ADDENDUM NO. CC-1

TELEGRAPH DISTRICT
401 BUILDING RENOVATION
LINCOLN, NEBRASKA
DLR GROUP PROJECT NO. 10-16202-00

February 26, 2016

5 ENLARGED RESTROOM PLAN - WOMEN 304
SCALE: 1/4" = 1'-0"

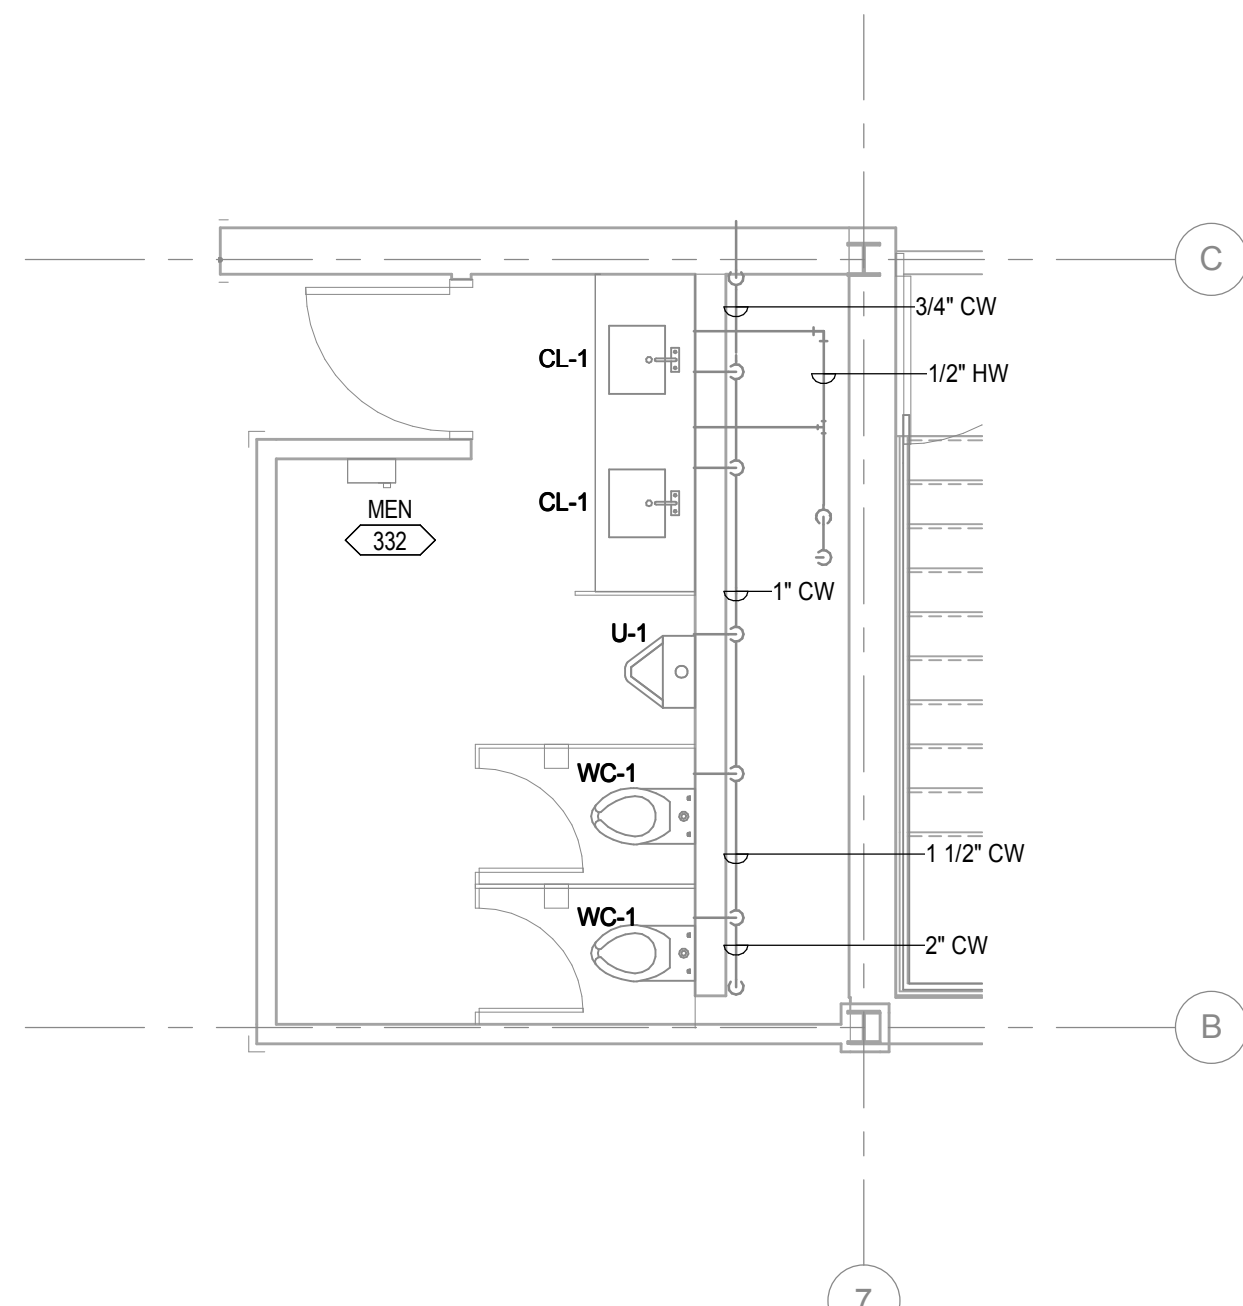
ITEM NO. 14 DRAWING P4.2 ENLARGED PLUMBING PLANS

- A. Revise the drawing as shown in the attachment P4.2 for modifications to the plumbing plan.
- B. Additional information has been added to clarify pipe sizing and routing.

MECHANICAL DEMOLITION PLAN, BASEMENT LEVEL
TELEGRAPH DISTRICT
401 BUILDING RENOVATION

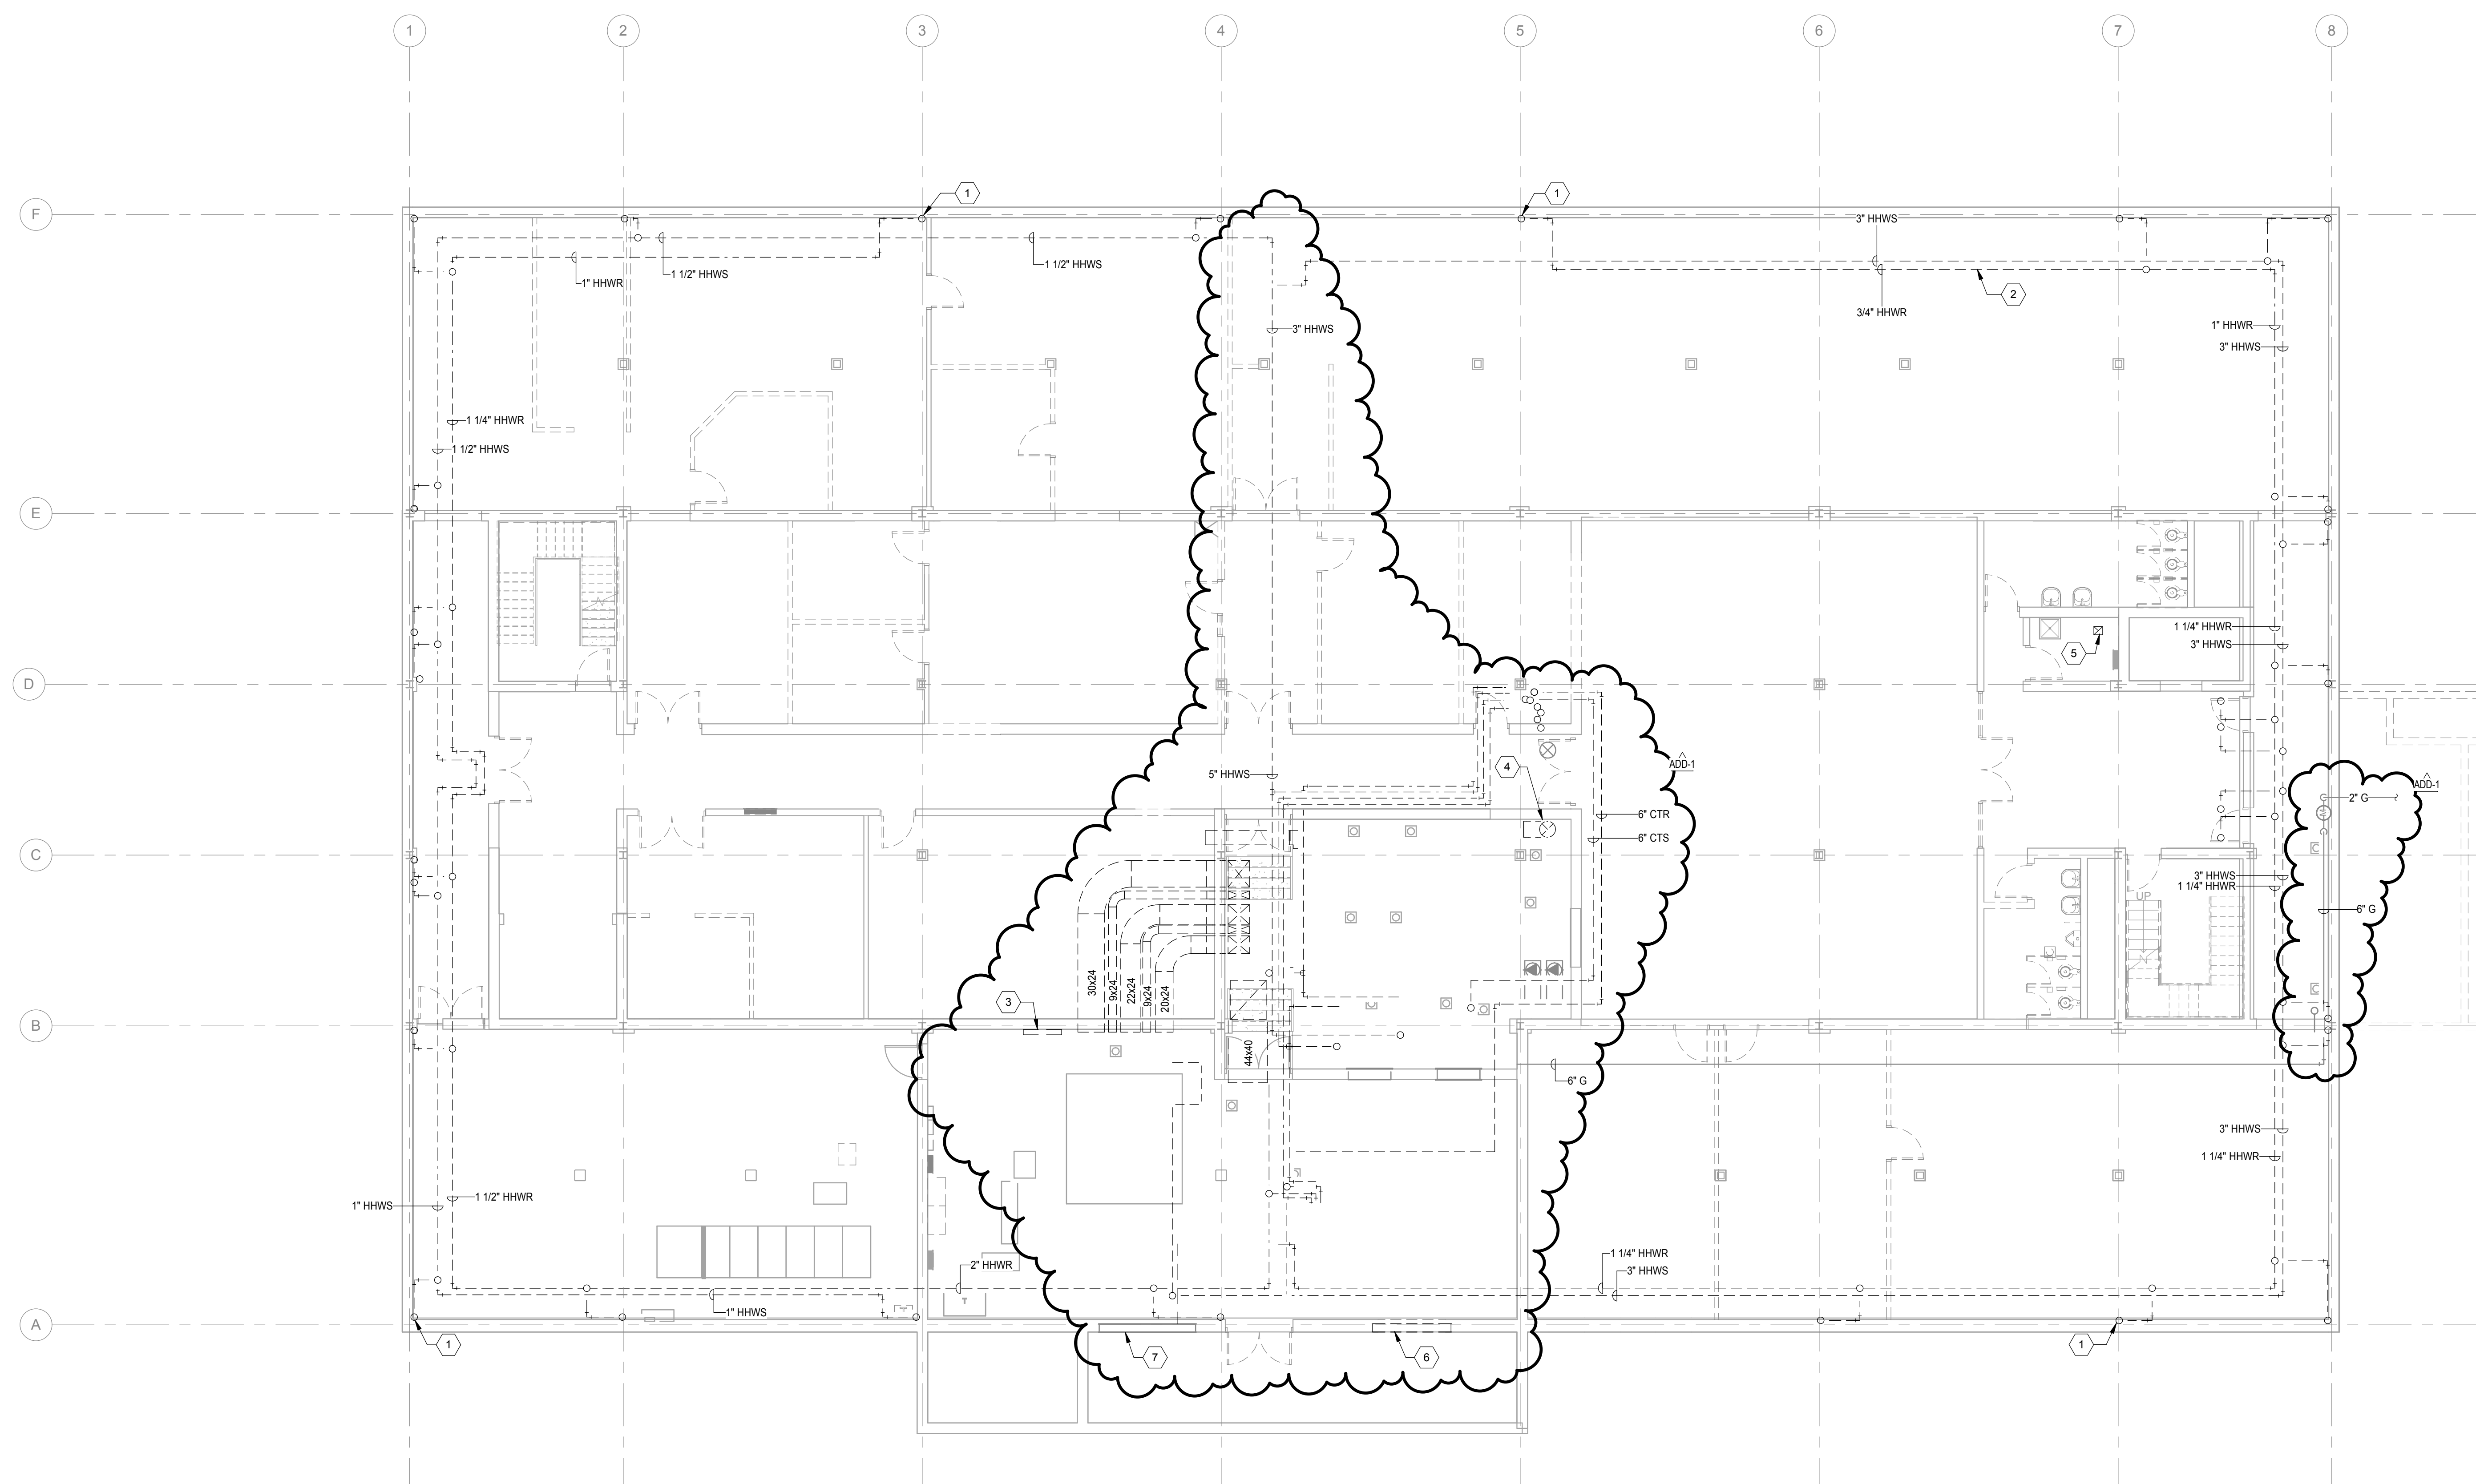
ITEM NO. 16 DRAWING MD1.0 MECHANICAL DEMOLITION PLAN, BASEMENT LEVEL

- A. Revise the drawing as shown in the attachment MD1.0 for modifications to the mechanical demolition plan.

HVAC PLAN, PENTHOUSE LEVEL

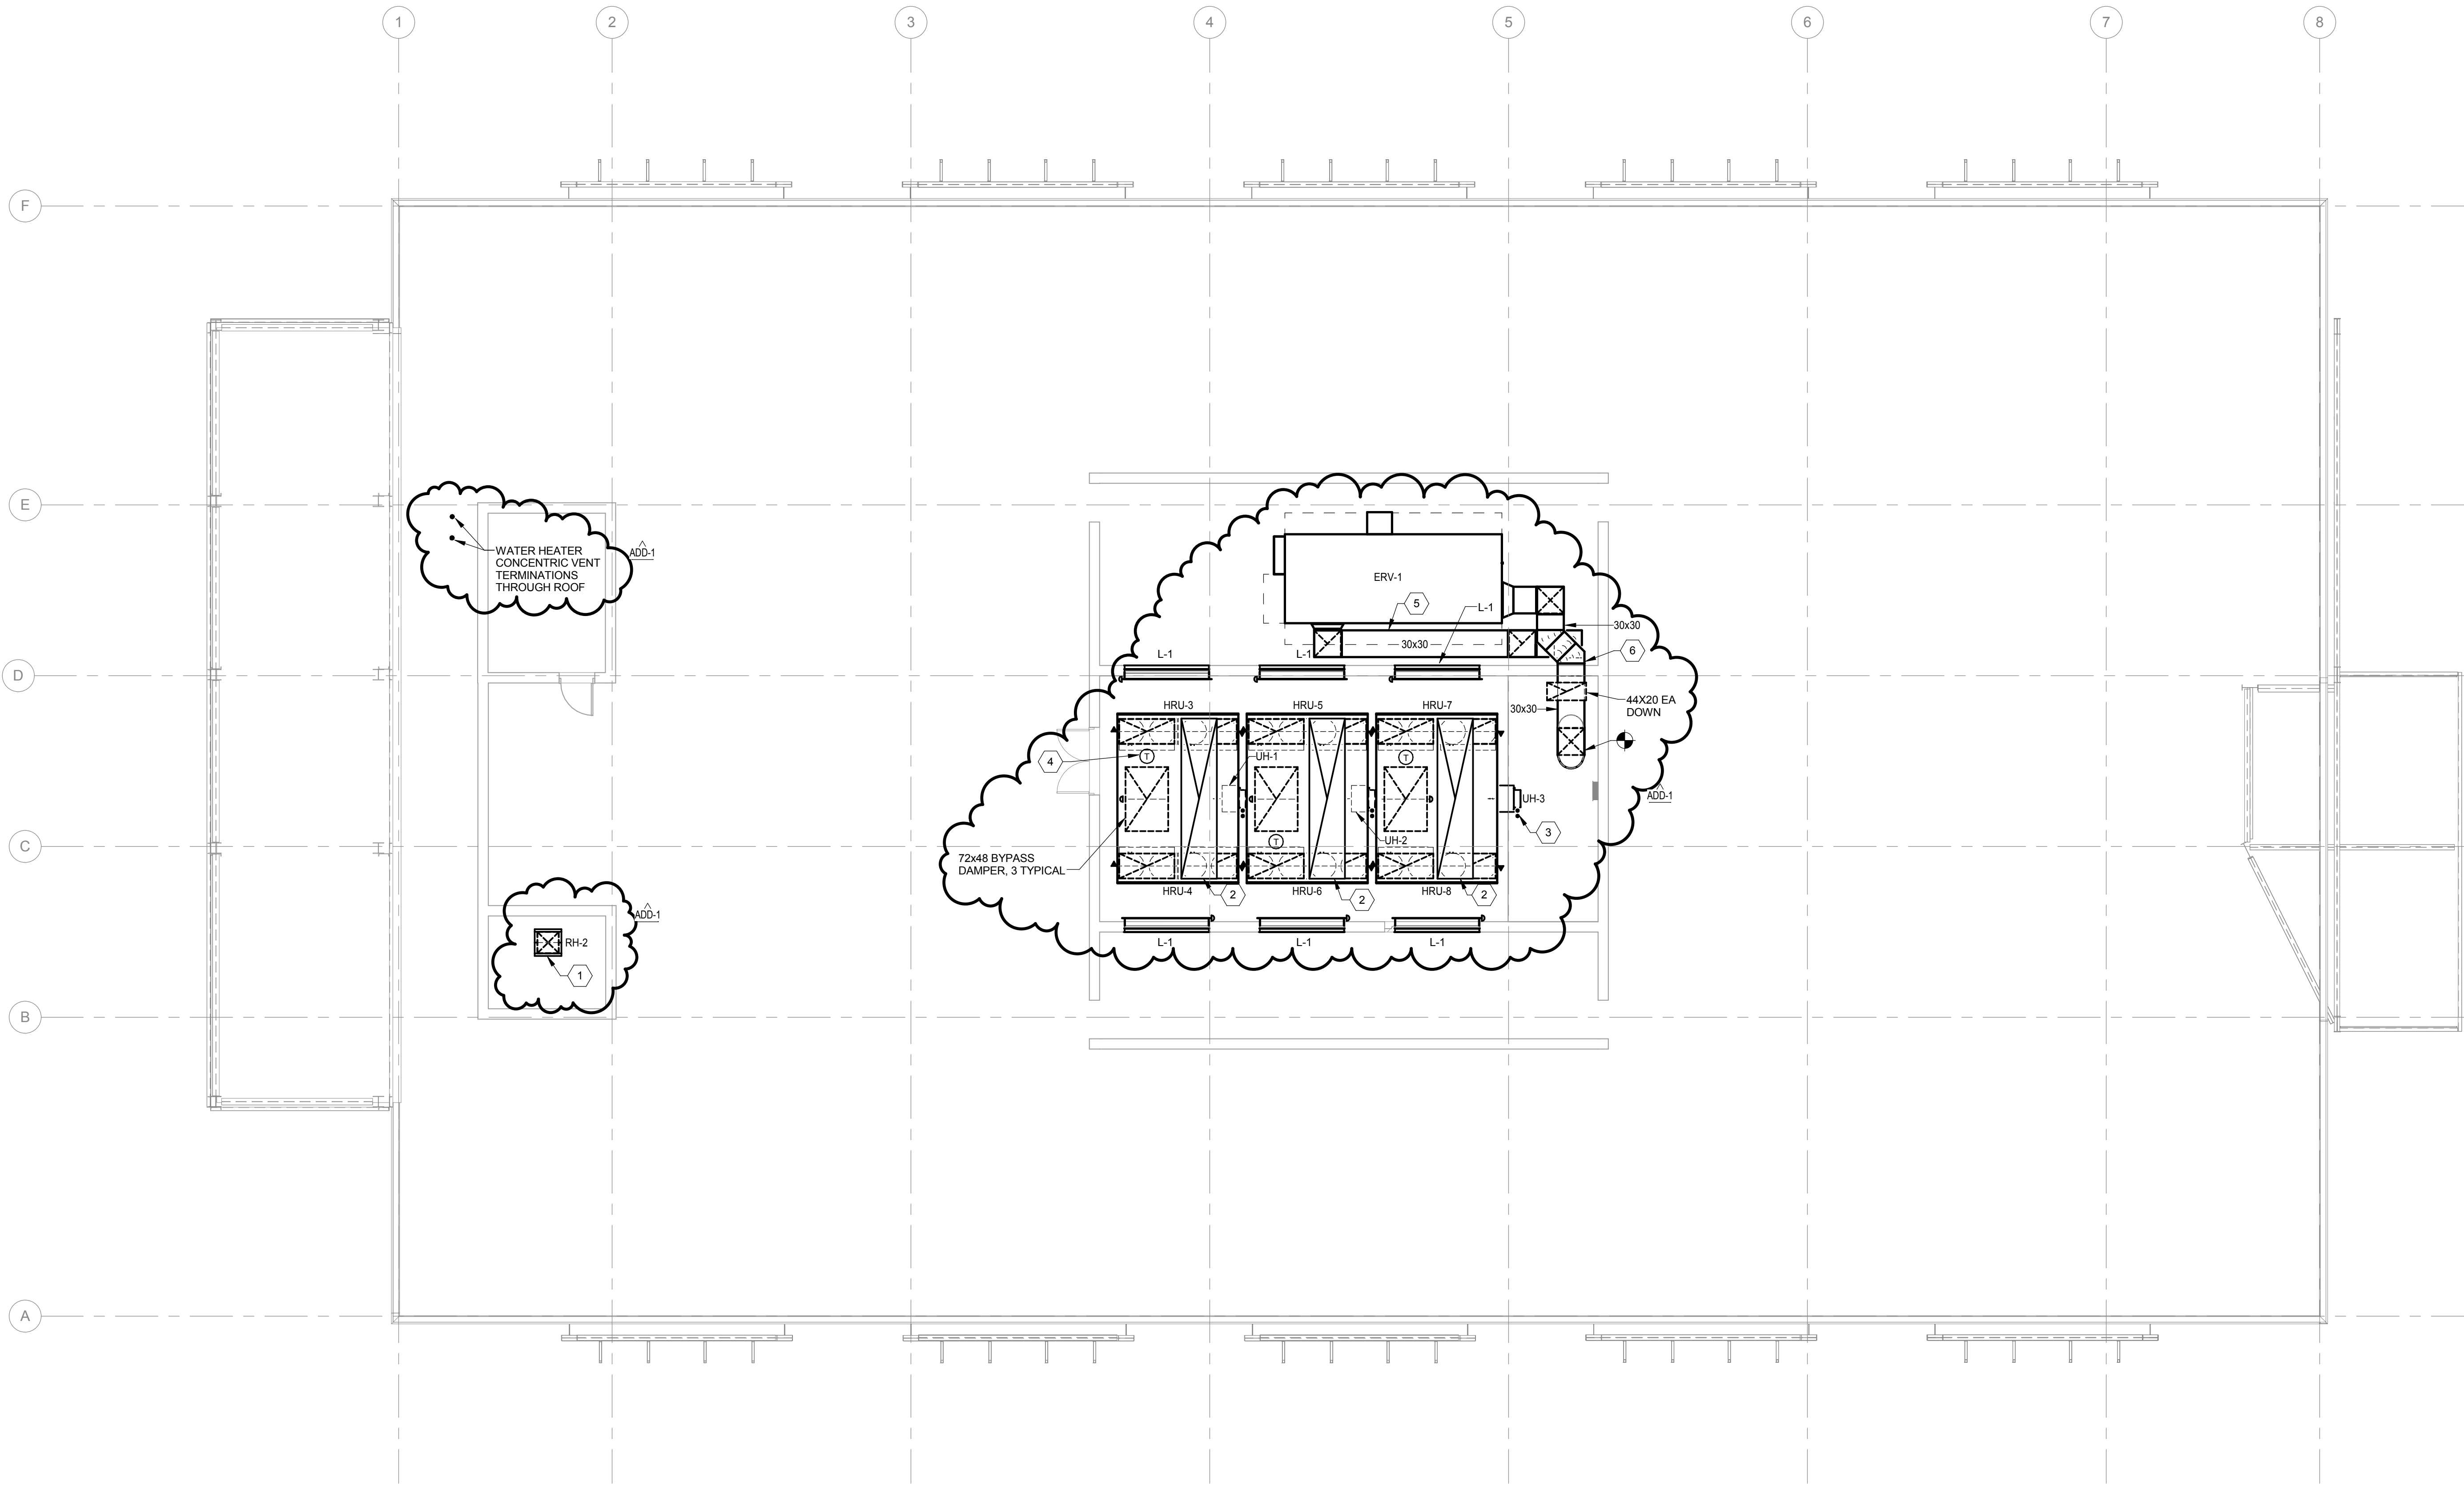
ITEM NO. 19 DRAWING M1.4 HVAC PLAN, PENTHOUSE LEVEL

- A. Revise the drawing as shown in the attachment M1.4 for modifications to the mechanical plan.
